Response to

Request for Additional Information No. 292, Supplement 1

U. S. EPR Standard Design Certification

Docket No. 52-020

Figure 2.7.1-1—Component Cooling Water System Functional Arrangement
Sheet 1 of 24

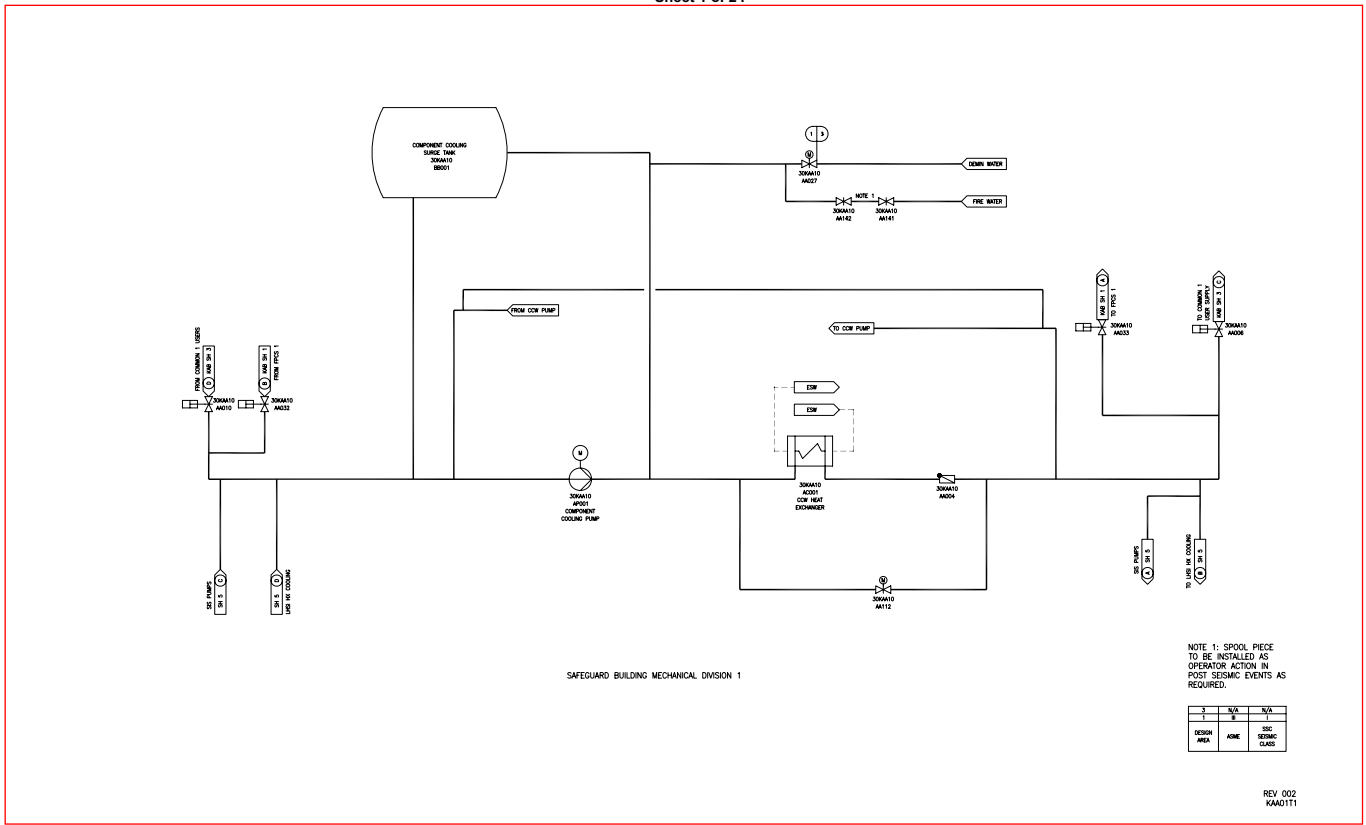
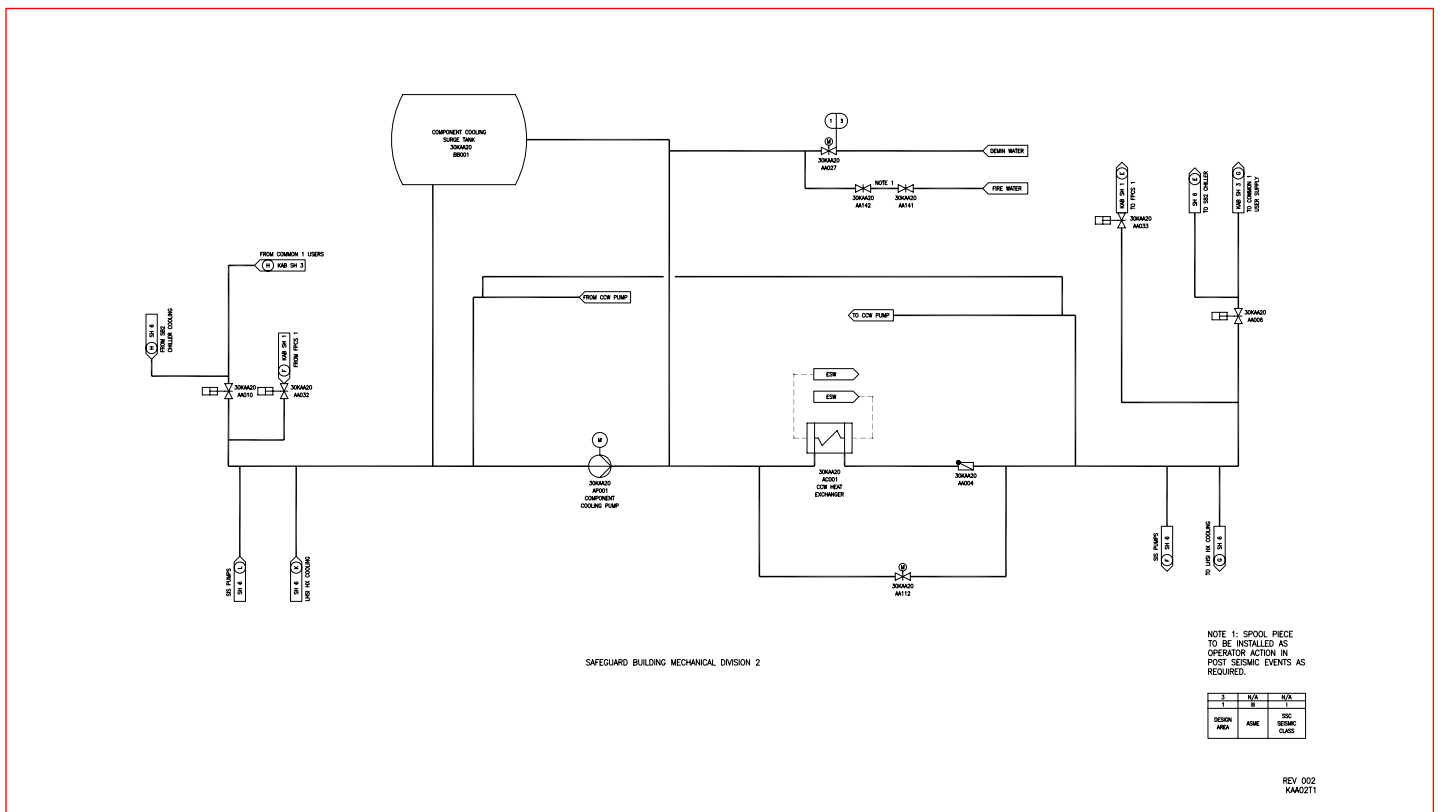
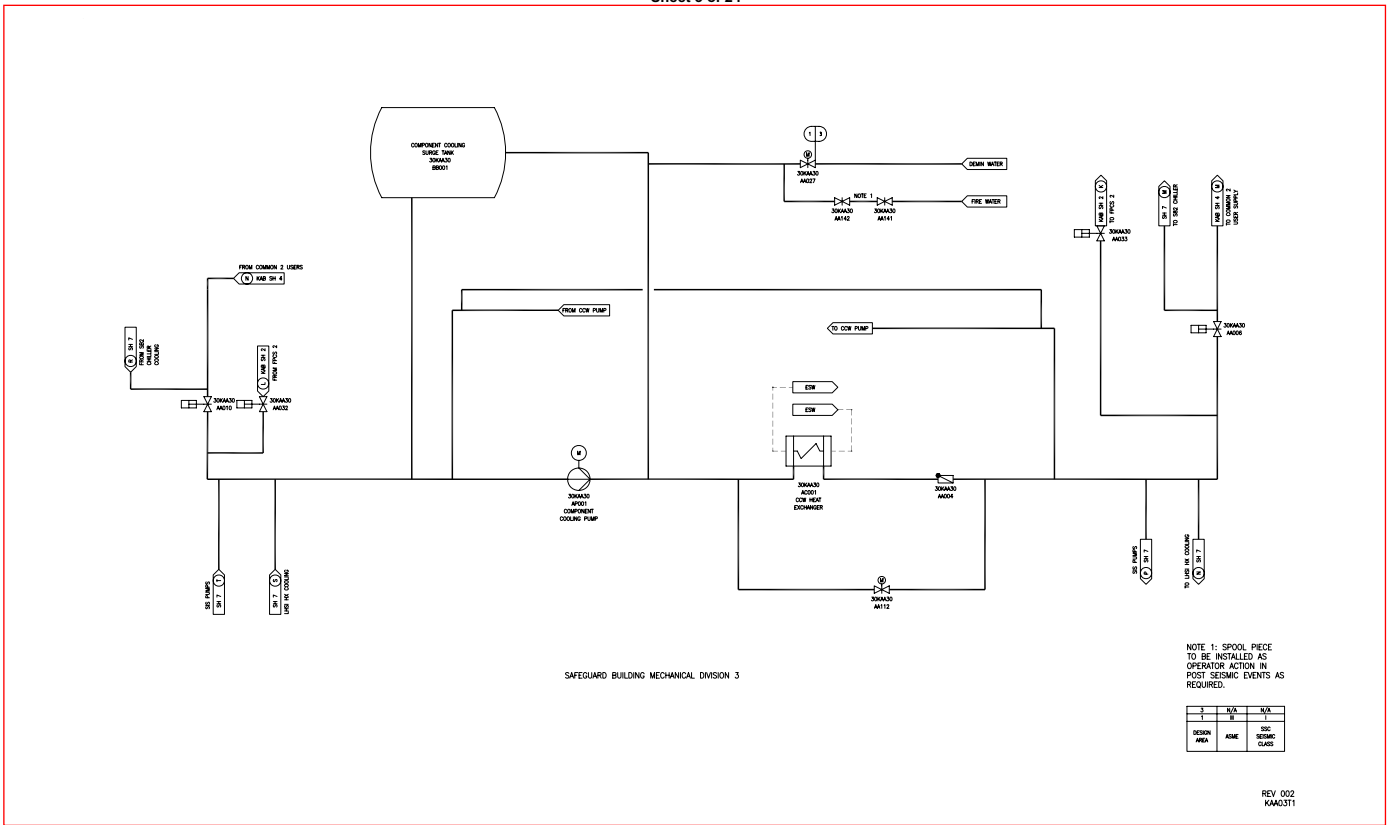
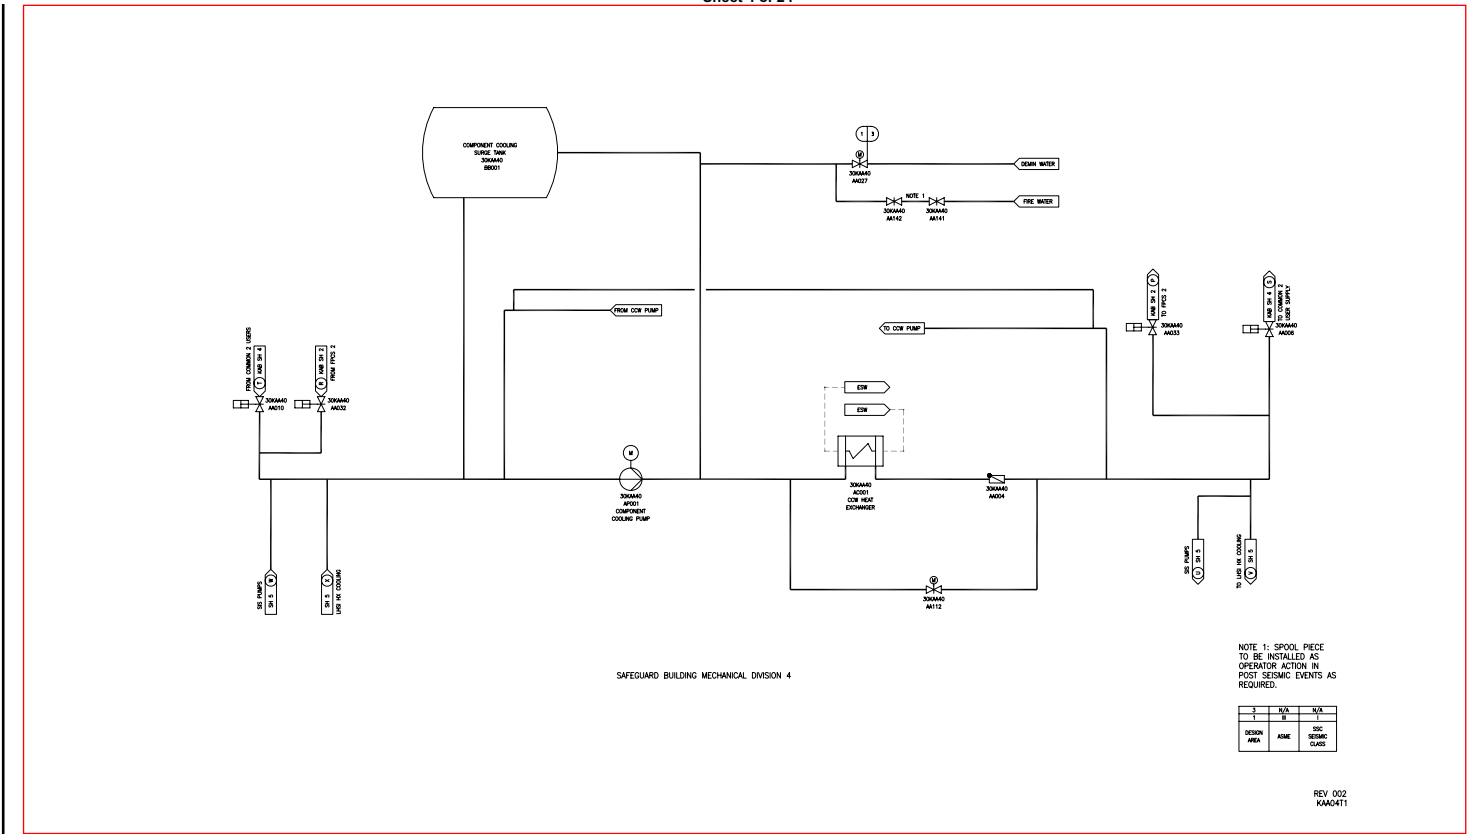
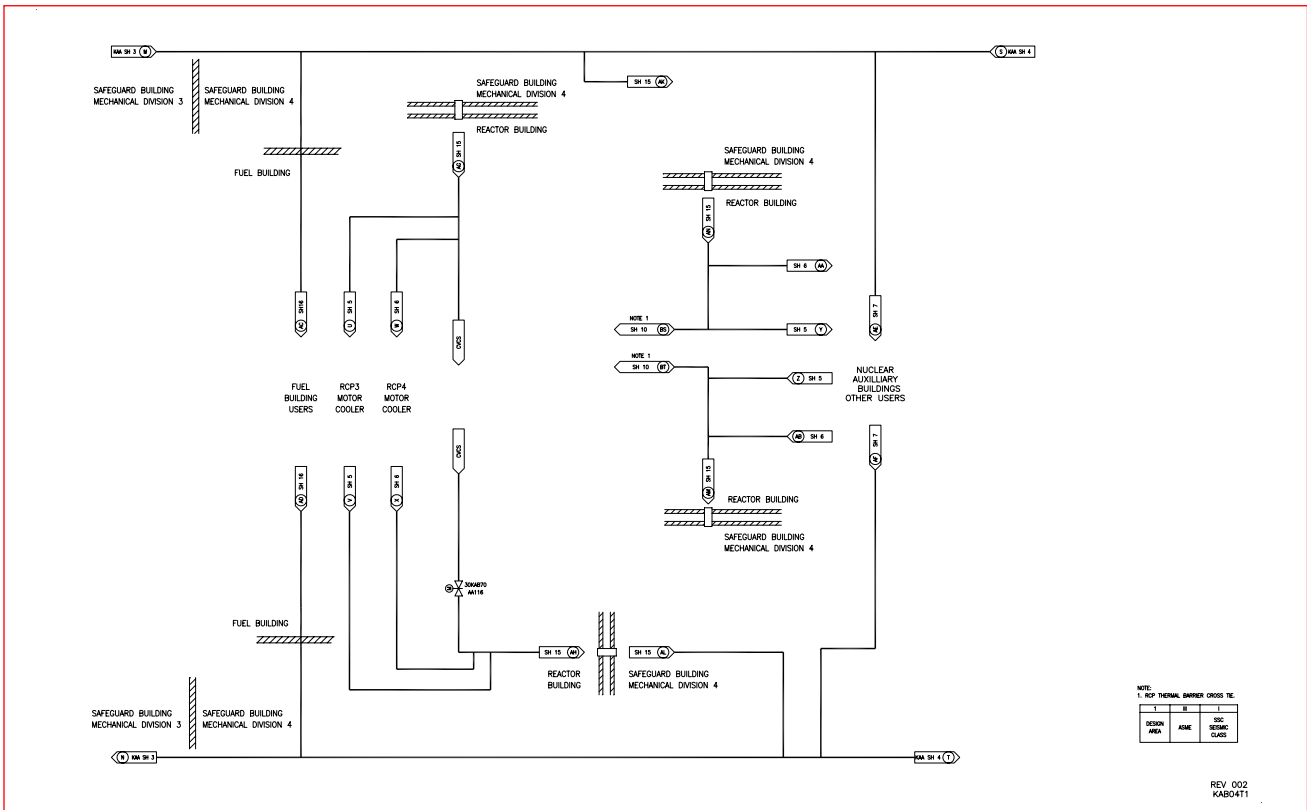
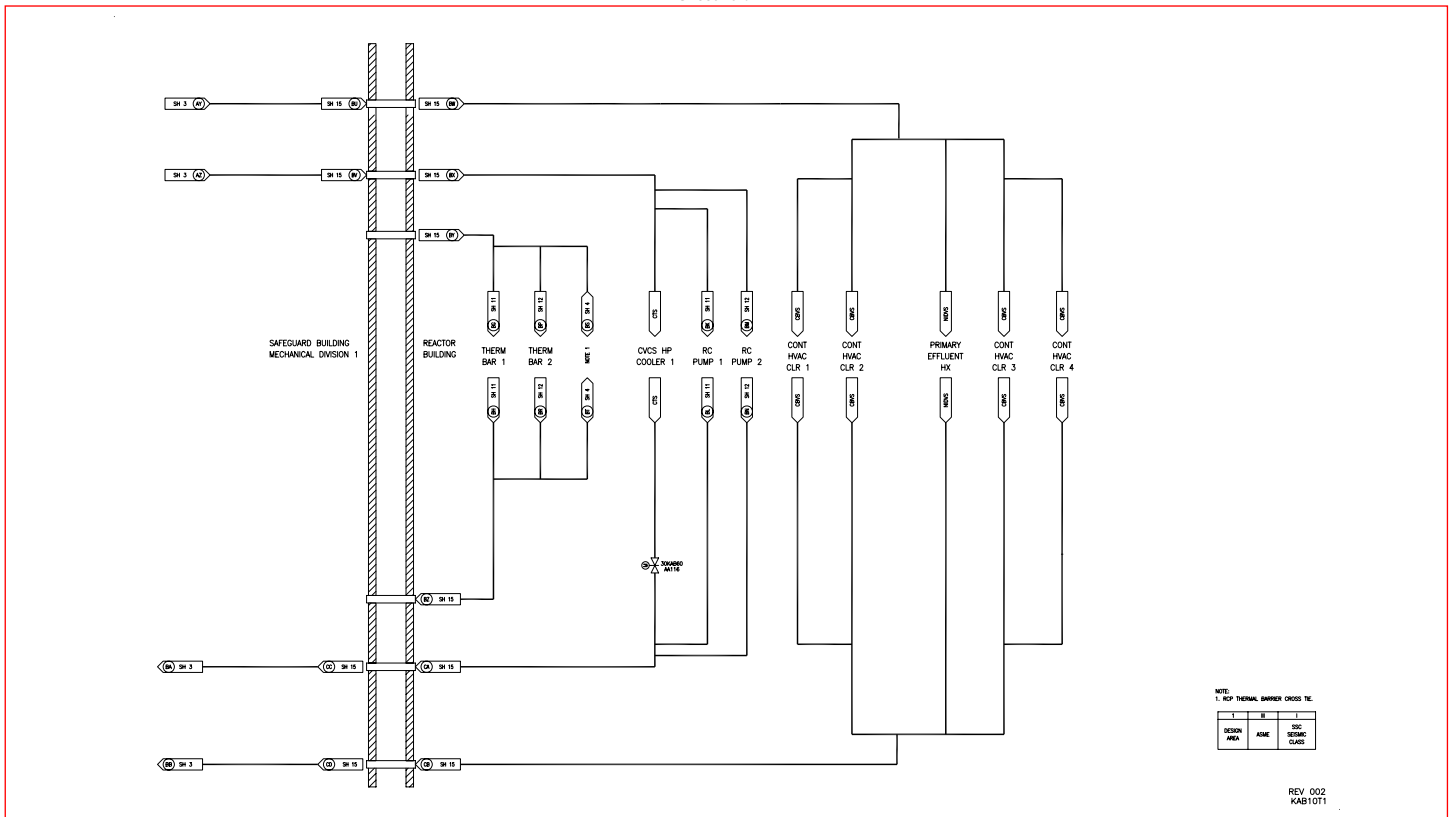
- e. review system design descriptions and address internal inconsistencies in the presentation of information presented under the headings of "I&C Design Features, Displays and Controls," and "Equipment and System Performance," and ITAAC tabulations. For example, such inconsistencies include listing radiation monitors in equipment description tabulations but not including the operational functions of radiation monitors in subsections on "I&C Design Features, Displays and Controls," and "Equipment and System Performance." Another type of inconsistencies includes differences in the functional arrangements of systems presented between Tier 1 and Tier 2 figures. For example, FSAR Tier 1, Figure 2.6.4-1 does not show the radiation monitor as compared to FSAR Tier 2, Figure 9.4.2-1, even though the radiation monitor has been assigned ITAACs in FSAR Tier 1, Table 2.6.4-3. The systems for which such inconsistencies were noted include the component cooling water system (CCWS), fuel building ventilation system (FBVS), safeguard building controlled-area ventilation system, containment building ventilation system, steam generator blowdown system, and the sampling activity monitoring system.

The component cooling water system (CCWS) is addressed in U.S. EPR FSAR Tier 1, Section 2.7.1. Radiation monitors are shown on U.S. EPR FSAR Tier 1, Figure 2.7.1-1, but without identifying information, such as tag numbers, because the ITAAC in U.S. EPR FSAR Tier 1, Table 2.7.1-3 do not apply to these components. The radiation monitors were deleted from U.S. EPR FSAR Tier 1, Table 2.7.1-2 in the Response to RAI 182, Supplement 4, Question 14.03-10, Part G “to remove non-1E powered radiation monitors and temperature control equipment for consistency with other U.S. EPR FSAR Tier 1 sections and SRP 14.3 guidance for safety significance determination.” U.S. EPR FSAR Tier 1, Figure 2.7.1-1 will be revised to delete the radiation monitors.

Figure 2.9.3-1—Gaseous Waste Processing System Functional Arrangement

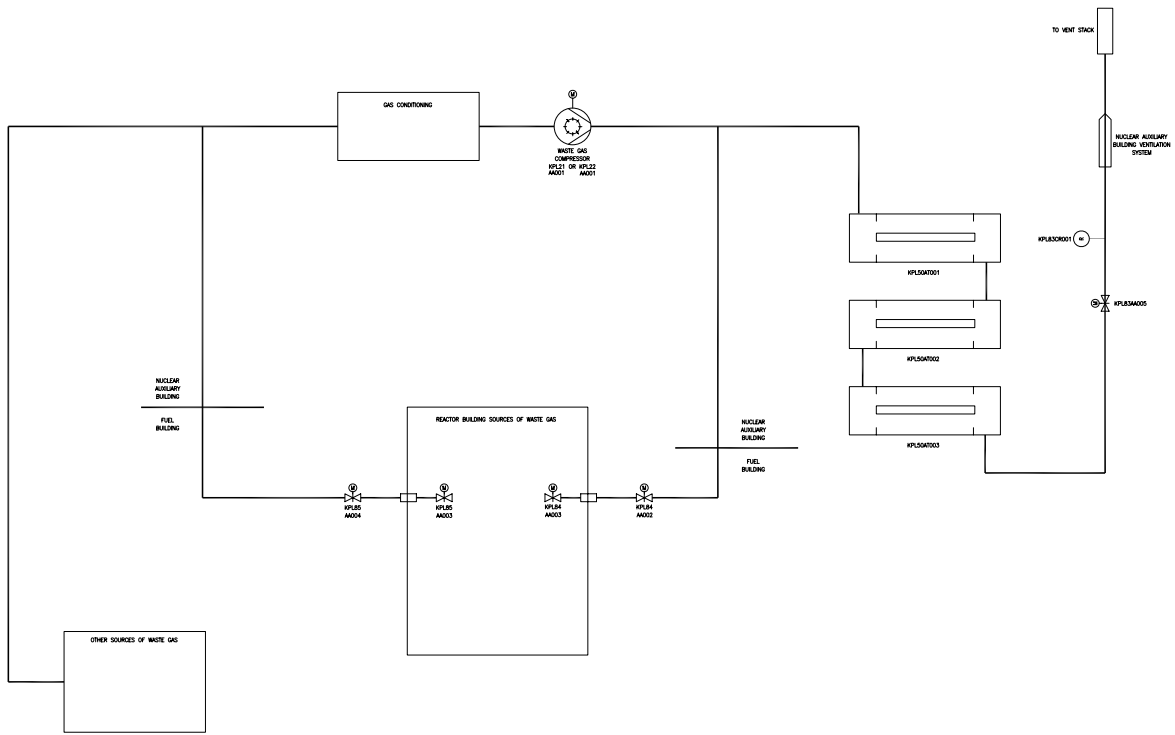
- b. review the design features of the LWMS, GWMS, and SGBS and assign ITAACs to confirm the proper operations of all automatic control features used to divert process streams and terminate effluent releases in meeting design descriptions and parameters given in FSAR Tier 2, Rev. 1, Sections 11.2 (LWMS), 11.3 (GWMS), and 10.4.8 (SGBS).

- d. review the design features of the GWMS and assign ITAACs in confirming the initial loading of the proper types and amounts of charcoal media and dessicant for the GWMS in meeting the design descriptions and parameters described in FSAR Tier 2, Rev. 1, Section 11.3. For the GWMS, the design commitments are expressed as retention times for noble gases in FSAR Tier 2, Rev. 1, Table 11.3-1, which are used to demonstrate compliance with Part 20 Appendix B, gaseous effluent concentration limits and offsite doses to members of the public, as shown in FSAR Tier 2, Tables 11.3-5 and 11.3-6.

- U.S. EPR FSAR Tier 1, Section 2.9.3 will be revised to add ITAAC to address safety-significant features of gaseous effluent monitoring (U.S. EPR FSAR Tier 2, Section 11.5.3.1) not already covered by the ITAAC described above. U.S. EPR FSAR Tier 2, Section 14.3.2 will be revised to provide additional details on the ITAAC selection criteria for radiation protection features, and U.S. EPR FSAR Tier 2, Table 14.3-8 will be revised to indicate that the gaseous waste processing system (GWPS) has ITAAC. U.S. EPR FSAR Tier 1, Table 3.5-1 and Table 3.5-2 will be revised to delete GWPS containment isolation valves (CIVs) (tag numbers KPL84AA003, KPL84AA002, KPL85AA003, KPL85AA004) because these valves are now covered by U.S. EPR FSAR Tier 1, Section 2.9.3. U.S. EPR FSAR Tier 1, Table 1.3-1 will be revised to add the acronym GWPS.

- U.S. EPR FSAR Tier 1, Section 2.9.3 was revised in part a) of this response to add ITAAC for the automatic closing of the GWPS discharge valve upon receipt of a high-radiation signal.

- d) The safety-significant filter media (activated charcoal) of the GWPS are addressed by U.S. EPR FSAR Tier 1, Table 2.9.1-3, Item 7.1 added in part a) of this response.
